SECTION 4.55(1A) APPLICATION TO AMEND SSD_9343 – MEADOWBANK SCHOOL

This letter has been prepared on behalf of NSW Department of Education (DoE) and School Infrastructure NSW (**the Proponent**) in support of a Section 4.55(1A) application to modify SSD_9343 in relation to Meadowbank Education and Employment Precinct Schools Project, at 2 Rhodes Street, Meadowbank (Lot 10 123584).

The application seeks to amend the approved architectural and landscape plans under Condition A2 to facilitate minor internal and external design changes.

Figure 1 Rhodes Street Facade

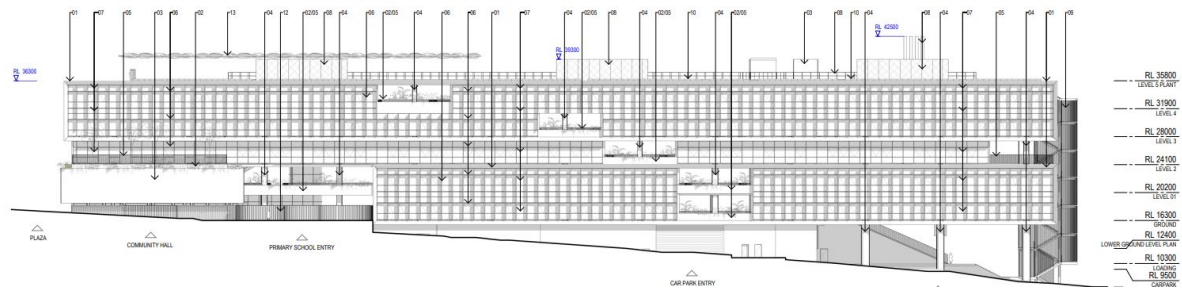
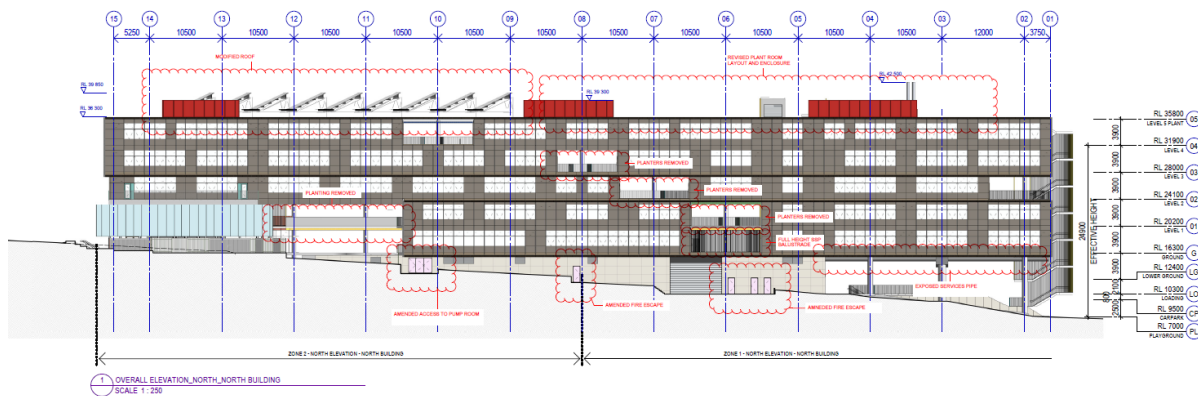
- The minor external changes retain the overall appearance and scale of the building. The external changes are a result of design development and do not detract from the original design intent. A comparison of the approved and proposed Rhodes Street frontage demonstrates that the external changes are minor and will barely be perceptible from the street.
